MEMORANDUM
DEVELOPMENT SERVICES/BUILDING DEPARTMENT

FROM: PETE JACKSON, ELECTRICAL SPECIALIST

SUBJECT: TARGET ROOF PV FIRE OF 4-5-09
9100 ROSEDALE HWY BAKERSFIELD, CALIFORNIA

Exhibit I

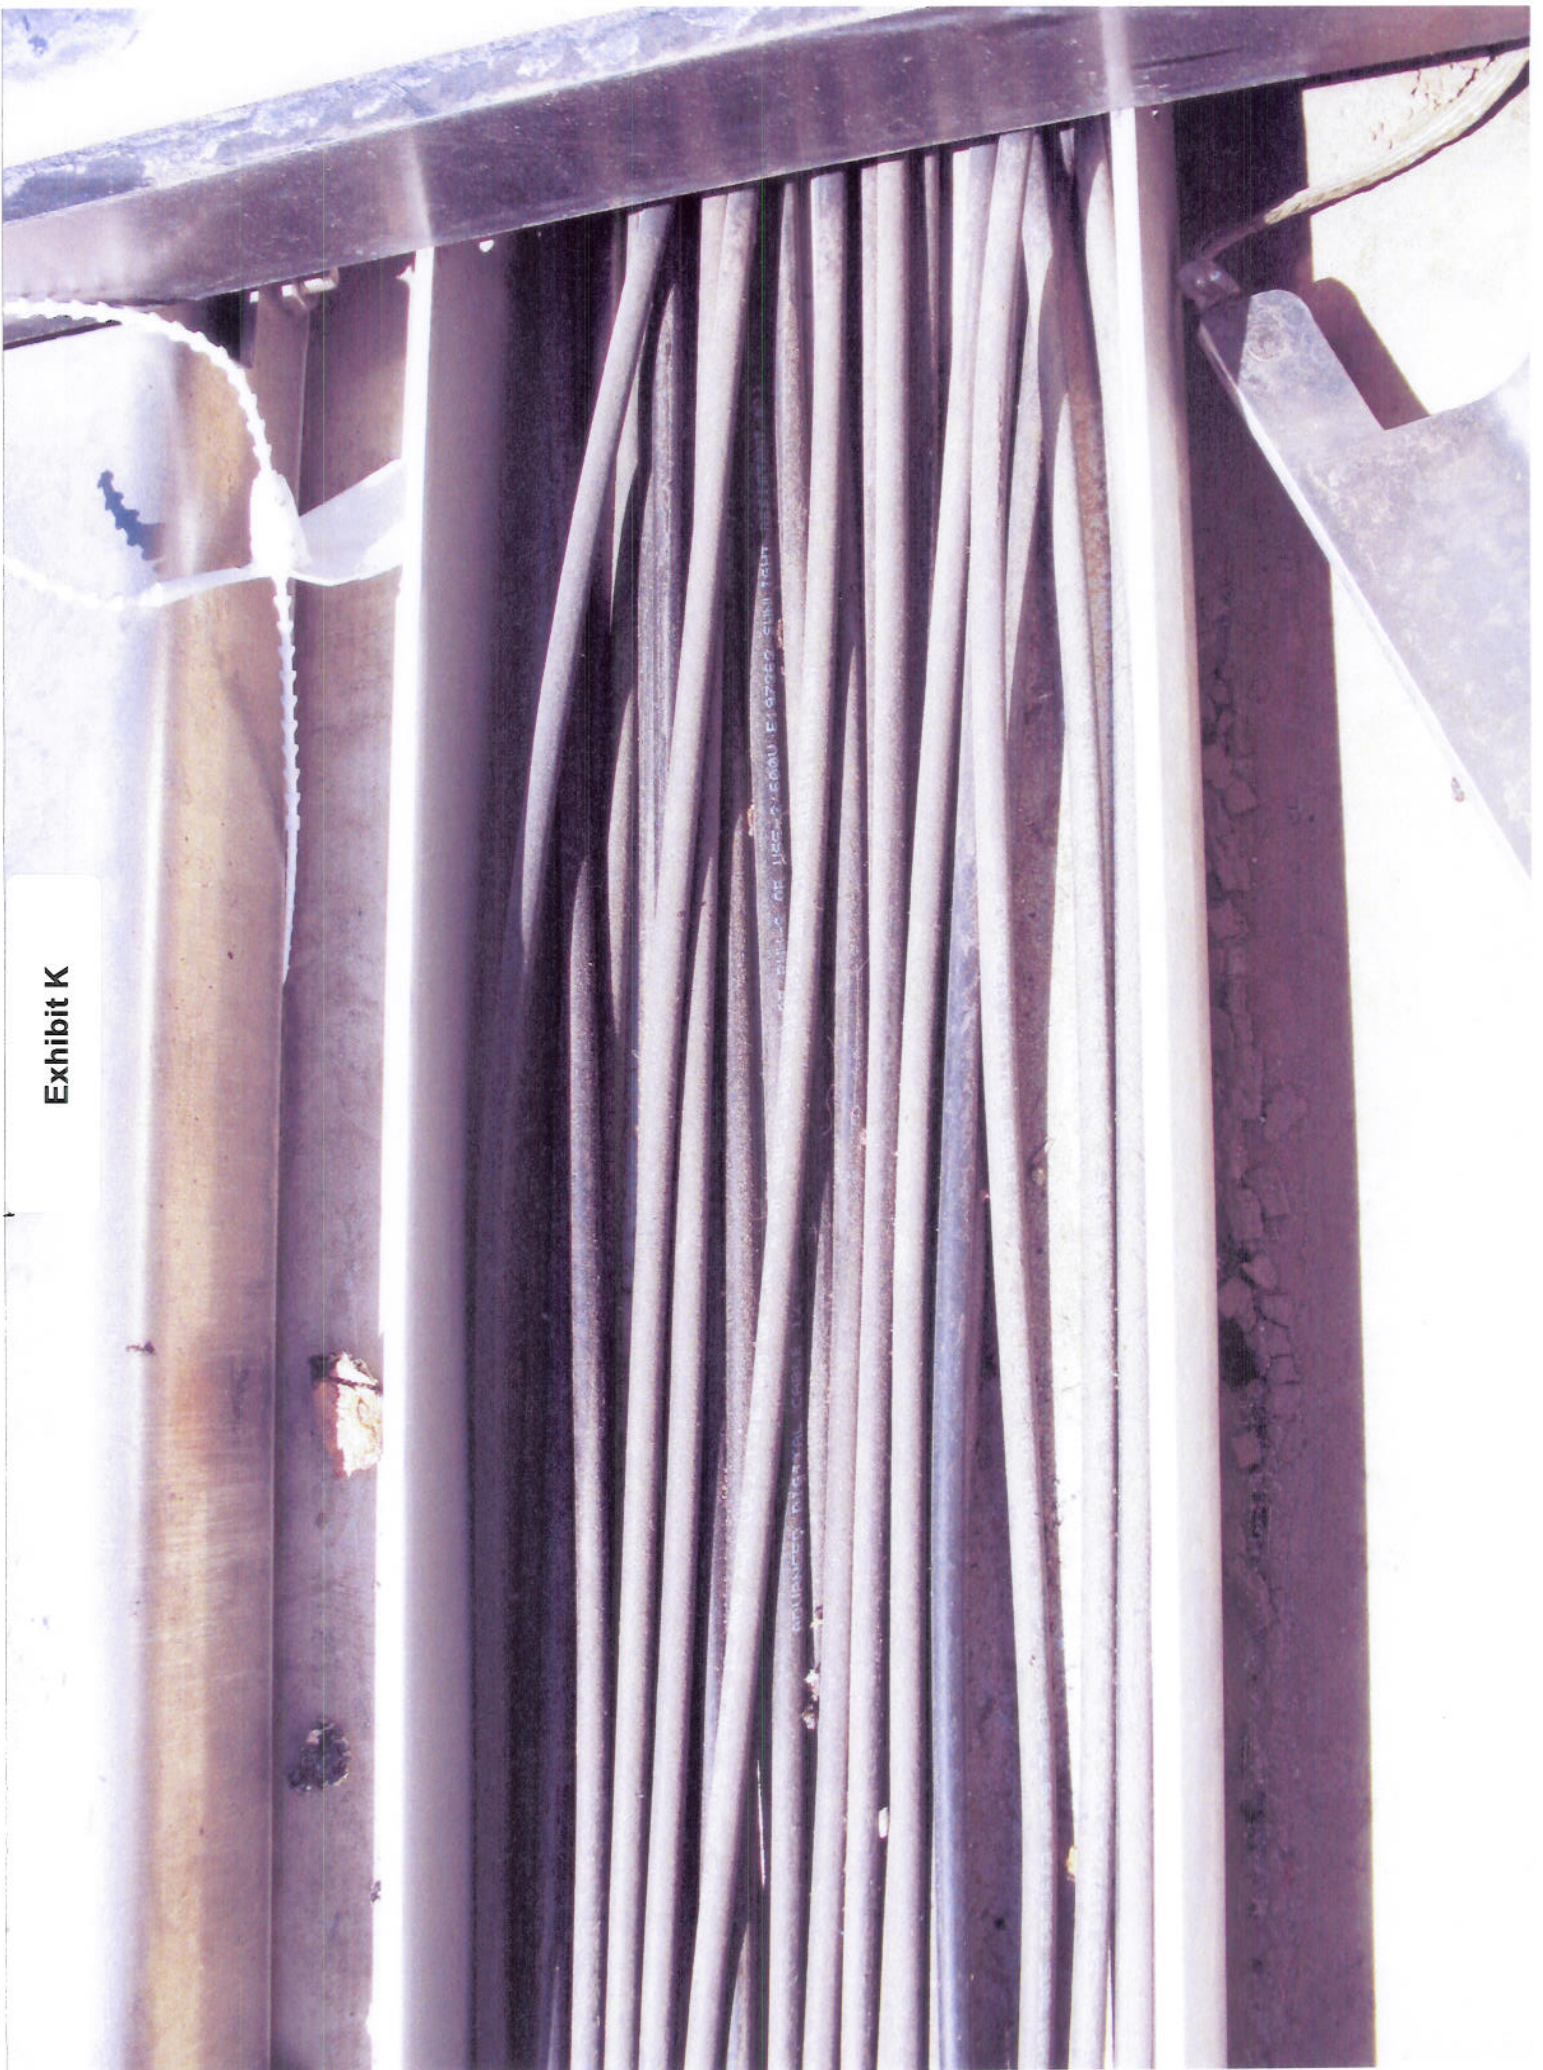
- 1) The row of modules which burned was included in Sub Array 1. Massive arcing occurred in the lid of the metal raceway between this row and the next row of modules towards Combiner Box A1. **See Exhibits I and J.**
- 2) Combiner Box A1 is the 56 string box which included Sub Array 1. All fuses in this box were removed and checked for continuity. The following fuses were observed to have opened:

Exhibit L

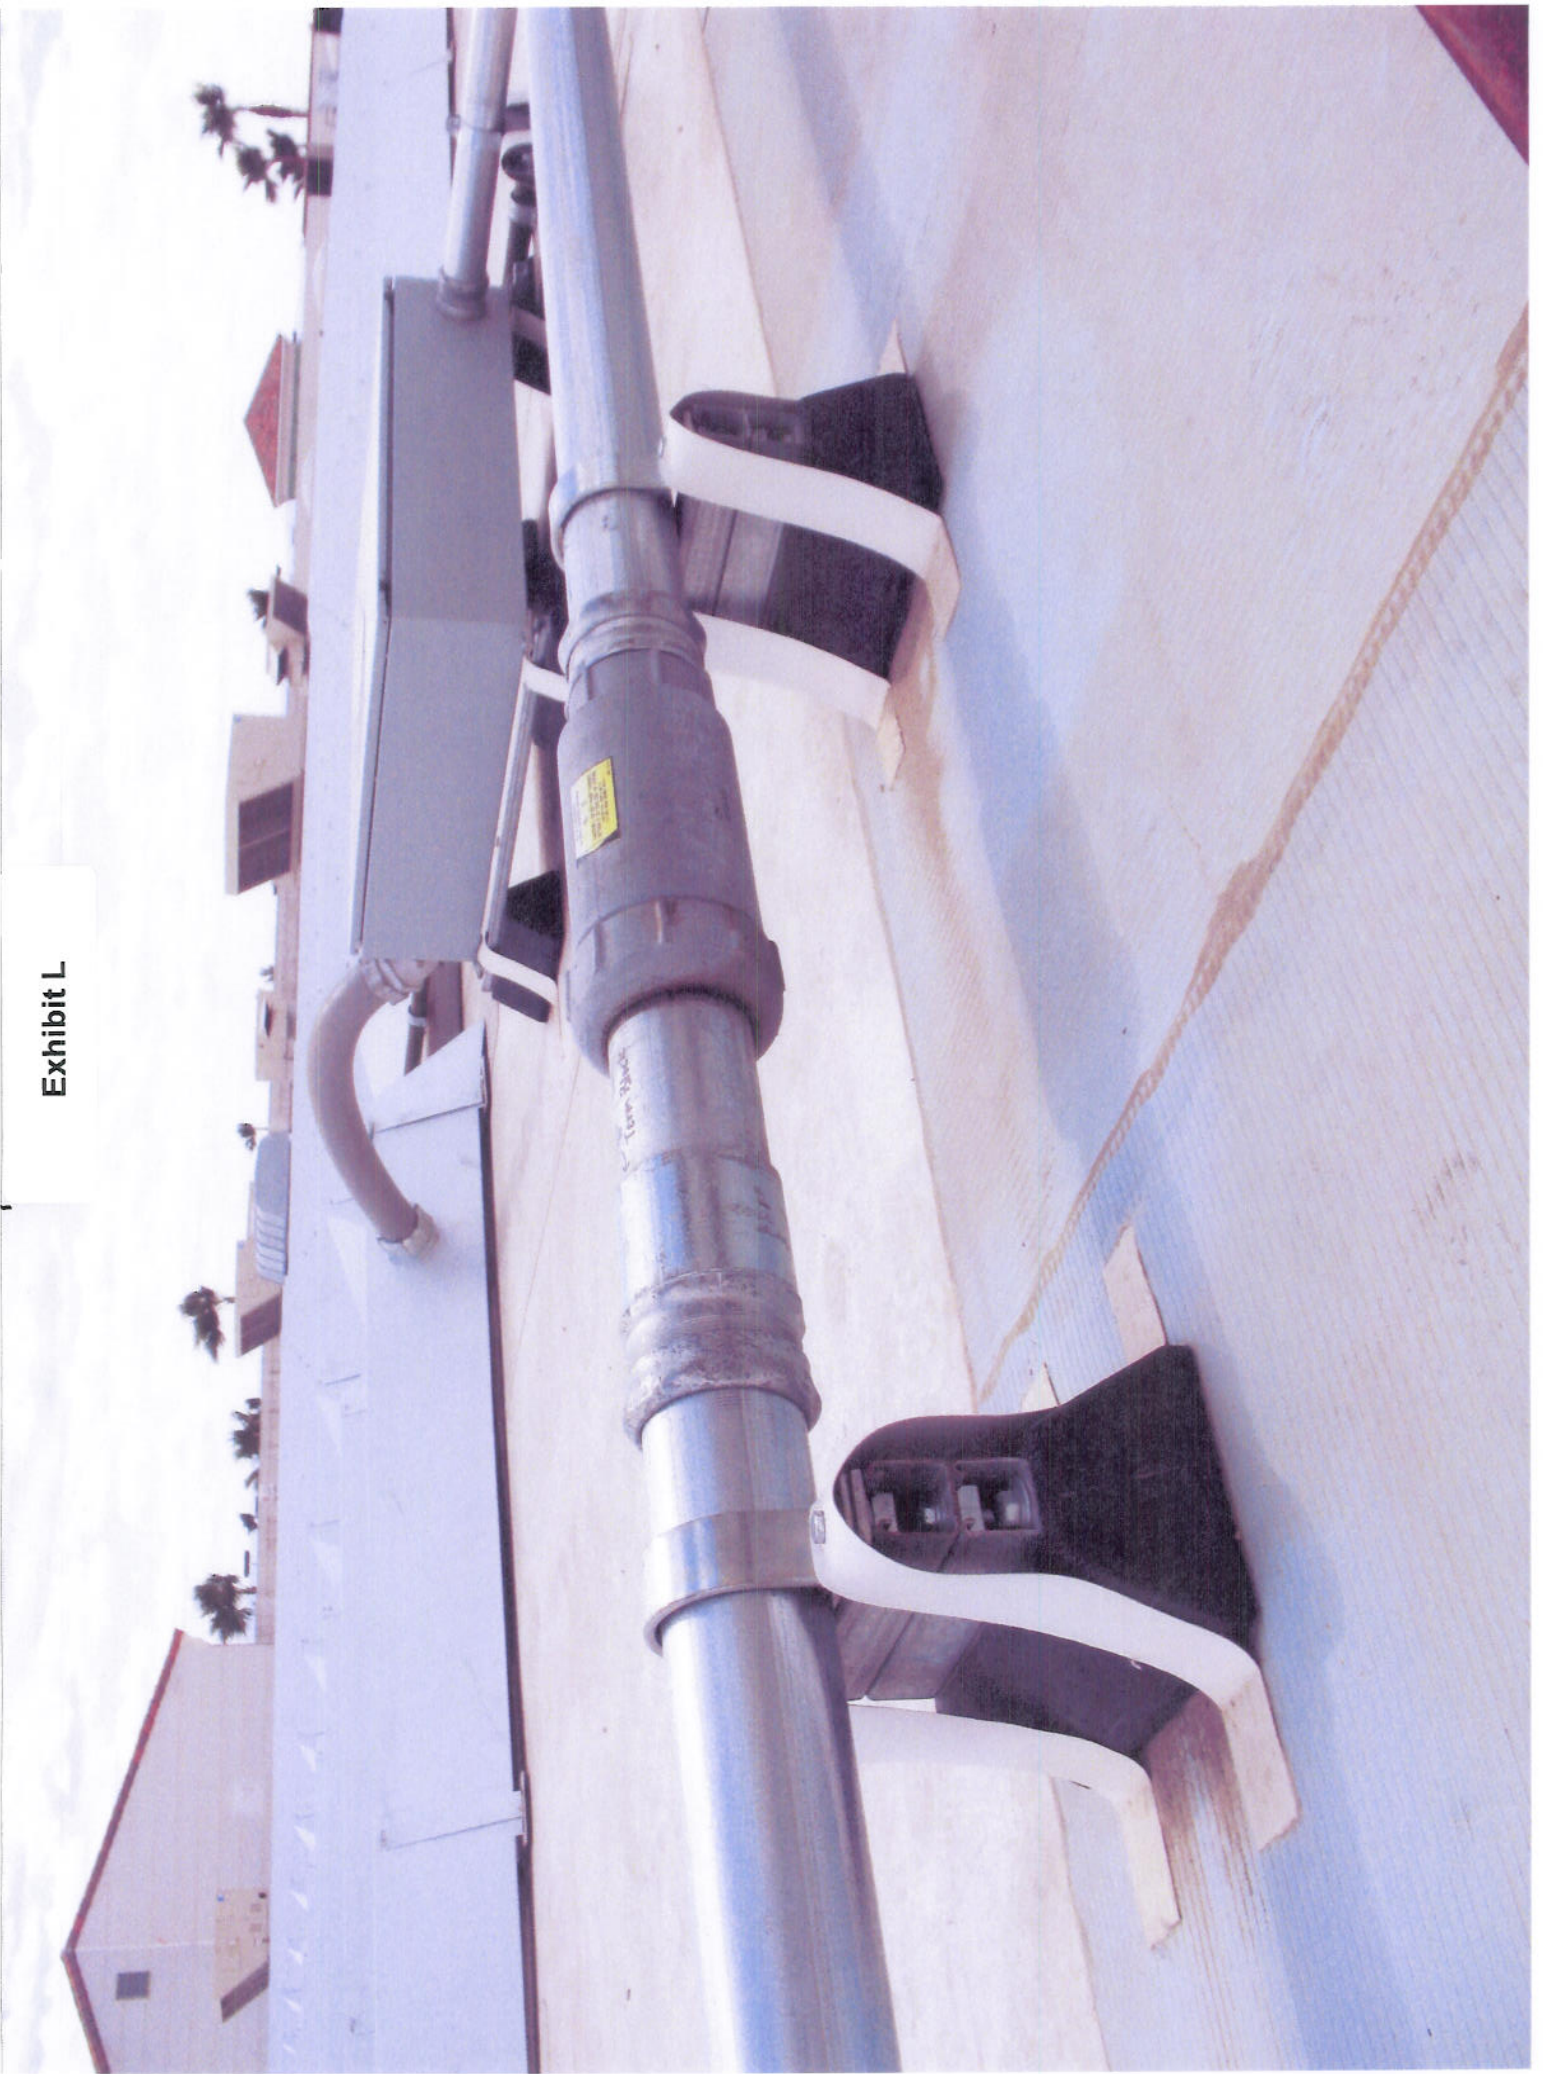
An O-Z GEDNEY AX series expansion coupling was installed 198 feet from Combiner Box A1 (30 feet from the conduit separation). This expansion coupling was not specified to be installed as a part of the design. **This fitting is not listed for use with EMT conduit.** It is intended to be used with RMC or IMC only (threaded conduit systems). The manufacturer produces another fitting for use with EMT. In addition, a mixture of different straps were used to secure the conduit to the UNITSTRUT topped blocks on the roof surface. A total of 24 POWERSTRUT PS1100 STD straps were used which would not allow movement of the conduit on its support blocks. One POWERSTRUT PS 3126 strap and nineteen UNISTRUT P 255830 straps were installed which may have allowed some movement since washers were installed under the clamps to provide annular space around the conduit. A review of the manufacturer's literature for both products did not indicate that the products were intended to be used for applications where movement in the conduit would be needed. **Both B-LINE and UNISTRUT (manufacturers of conduit straps) specify both a one-piece strap which is one pipe size larger than the conduit used or a two piece strap with an insert between the strap and pipe which allows conduit movement in their product catalogs. A B-LINE representative who visited the site confirmed this as well.** The conduits are all supported and secured on the roof by recycled rubber blocks which have a UNISTRUT type of channel for connection of the pipe straps. These blocks are then attached to the roof membrane by strapping (made with the roof material) to the roof itself in accordance with the roofing product standards. These roof support blocks are not designed to slide or move on this roof. If movement is to occur it should occur with the conduit moving on the UNISTRUT topped blocks, not the rubber blocks moving on the PVC roof. **The conduit had an expansion and contraction linear movement of 3.7 inches. The incorrect expansion fitting and straps could cause the movement to occur at one or more of the compression couplings. A loose coupling would very possibly experience the most movement. Conductor insulation damage is a likely result. Conductor insulation damage did occur here. There would be no faults without insulation damage at this point. See Exhibits G, H, L and M.**

- 1) High voltage insulation testing (megger) all of the existing system wiring and any new or repaired wiring per CEC 110.7.
- 2) The conduit systems installed on the roof need to be engineered for the thermal expansion which will occur per CEC (NEC) 300.7 (B) FPN. Expansion fittings and straps listed for the purpose and the conduit system installed must be utilized.
